18 REPORTS FROM OFFICERS – PLANNING AND INFRASTRUCTURE DIRECTORATE

18.1 629-639 PACIFIC HIGHWAY, CHATSWOOD - PLANNING PROPOSAL

MEETING DATE:

12 FEBRUARY 2018

Figure 7

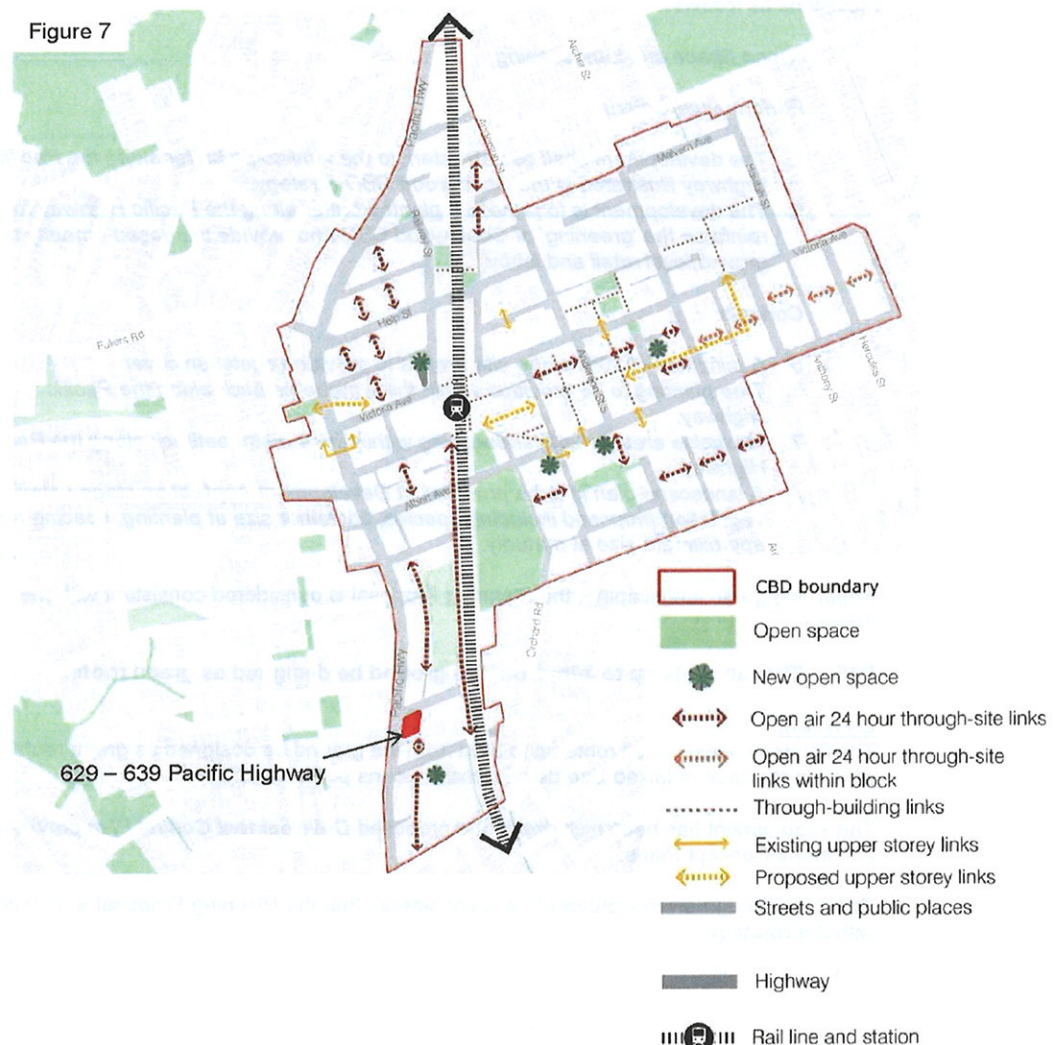
The subject site is not subject to any identified existing or proposed pedestrian or cycle linkages or open space, as shown below in Figure 7. However it should be noted that a pedestrian and cycle linkage is sought connecting Nelson Street (and the Metro Dive site) with Gordon Avenue via Hammond Lane to the immediate rear of the subject site.

The Planning Proposal does not preclude this linkage from being achieved.

Figure 8

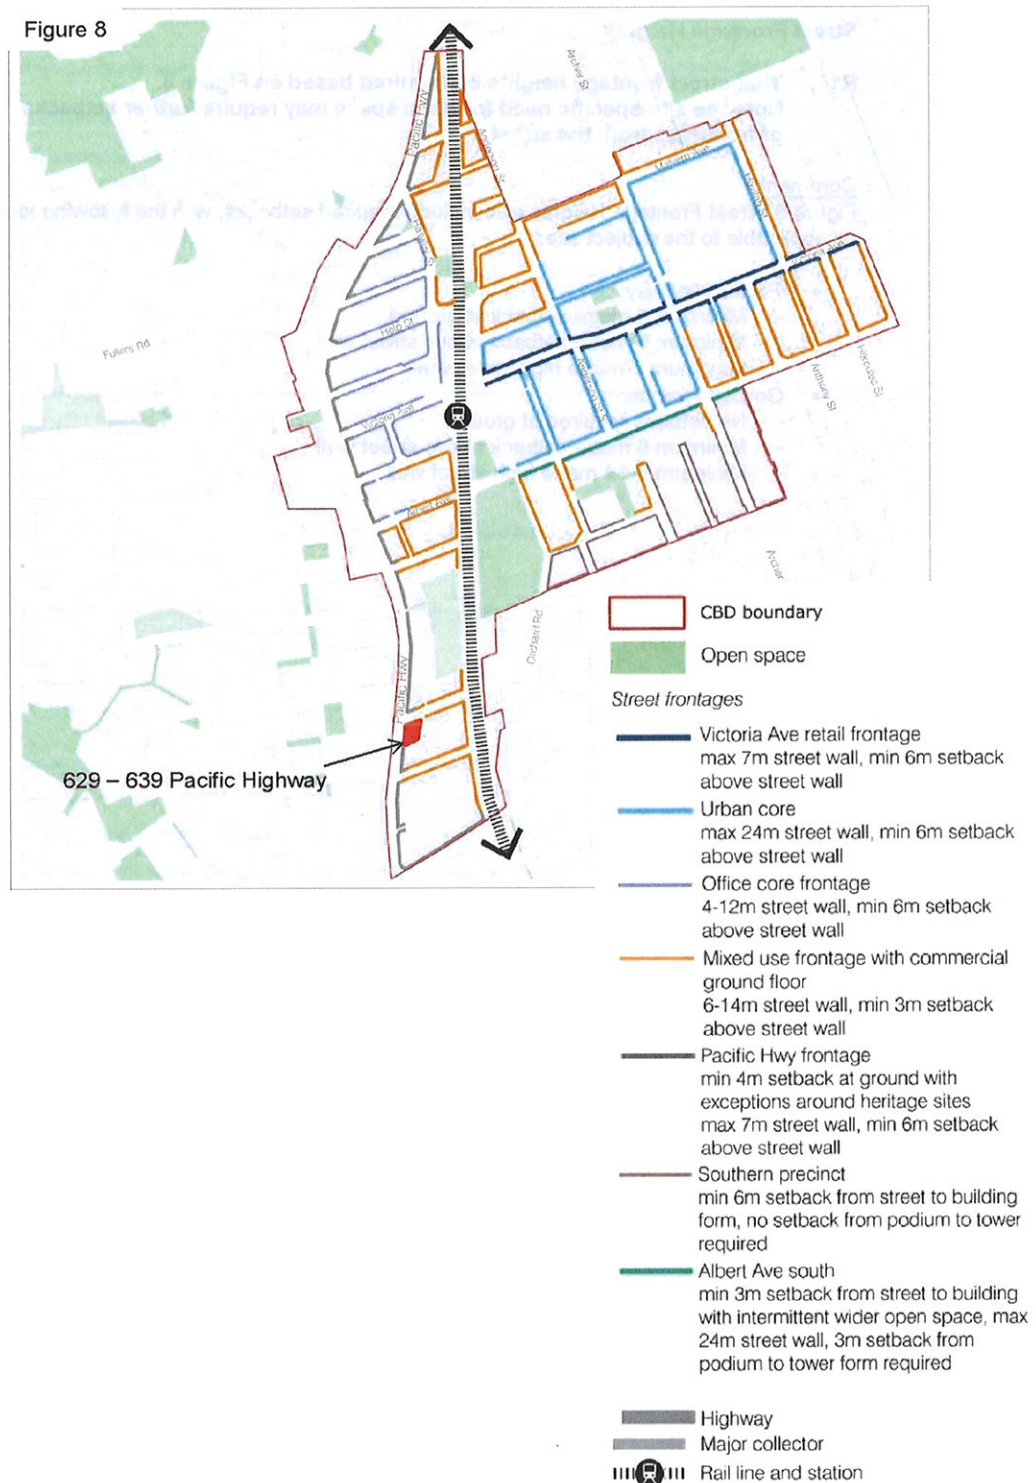
Figure 8 Street Frontage Heights also include required setbacks, with the following identified as applicable to the subject site:

- Pacific Highway:
 - Minimum 4 metre setback at ground
 - Minimum 6 metre setback above street wall
 - Maximum 7 metre high street wall
- Gordon Avenue:
 - No setback required at ground
 - Minimum 6 metre setback above street wall
 - Minimum 6-14 metre high street wall

The December 2017 Concept Plans are consistent with the above Figure 8 requirements applying to the subject site, with one variation:

"Commercial floor space is required to provide significantly higher floor to ceiling heights than is the case for residential floor space. A floor to ceiling height clearance of 4.2m is required for the ground floor and 3.6m for the first floor level, resulting in a minimum podium height of 7.8m. It is requested that Council allow for a maximum podium height of 8m to ensure appropriate floor to ceiling height clearances."

Based on the satisfactory addressing of setback requirements, the reduced impact of a two level Podium across the site and the importance of a viable commercial component of this mixed development, it is deemed reasonable to forward the Planning Proposal with this variation to the Gateway for further consideration.
